Planning Commission Minutes

December 9, 2019

19-RZN-01, 19-APUD-08 – Consideration of a request for rezoning and an amendment to the Market Plaza / Village Shores planned unit development, requesting approval of a new building for a bank branch with a drive-up ATM.

From: Sean Hayford Oleary <sdho@sdho.org>
Sent: Friday, December 06, 2019 7:19 PM
To: Matt Brillhart; Melissa Poehlman
Subject: Concerns and questions — Market Plaza

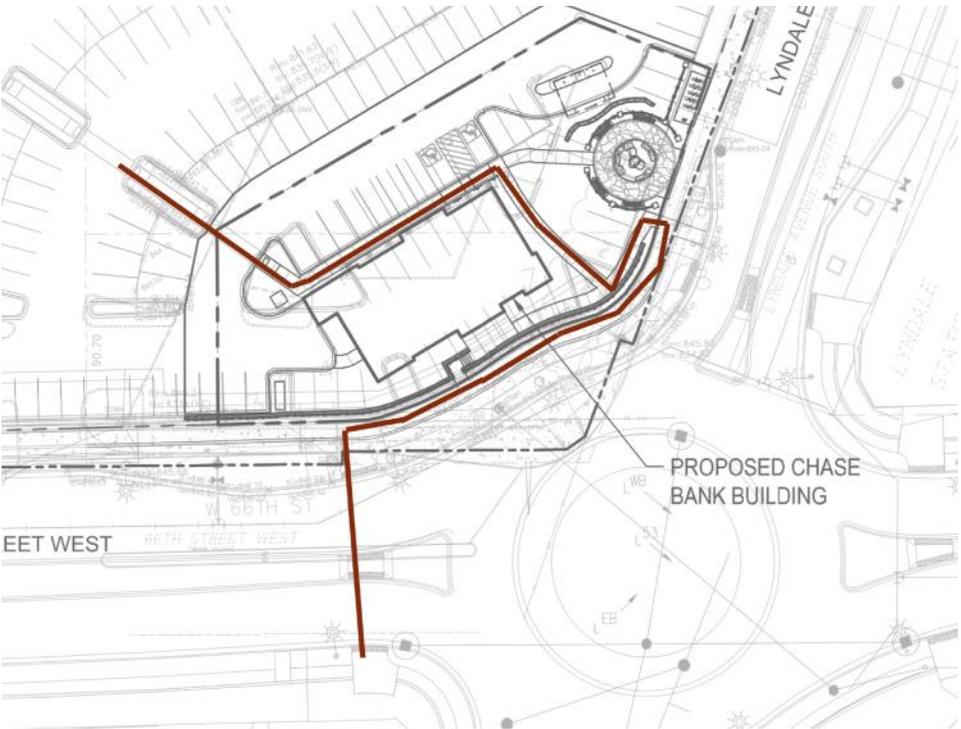
The existing parking lot / plaza area is roughly at grade with sidewalk -- about 6" below. The developer is proposing to lower the existing grade to about 3' below sidewalk grade. Although they provide stairs, the street presence of the building is significantly affected by it being partly underground. Critically for me: it is a much worse street presence — both for pedestrians and people driving past — than the other three corners of the same intersection.

I assume they want to lower it to make it match the height of the parking lot, while minimizing regrading of the lot. However, it seems like there are several other options that could have been pursued:

- a.) A larger area of the parking lot could be regraded so that both entrances could be at sidewalk-grade
- b.) The ramp and stairs could be provided on the parking lot side, rather than the street side
- c.) The developer could have built a vestibule at a "half-story" with ramp and stairs internal to the building — less subject to ice and snow, and providing a much more welcoming and attractive entrance.

Question: Were any of these options explored? Is there a reason they are not viable?

Commissioner Hayford Oleary stated concerns with the building being below grade and inquired if the applicant could regrade a larger area of the parking lot so that the building entry could be at-grade with the sidewalk. The applicant responded that they could not change the grade at the center of the parking lot and they felt this was the best solution.
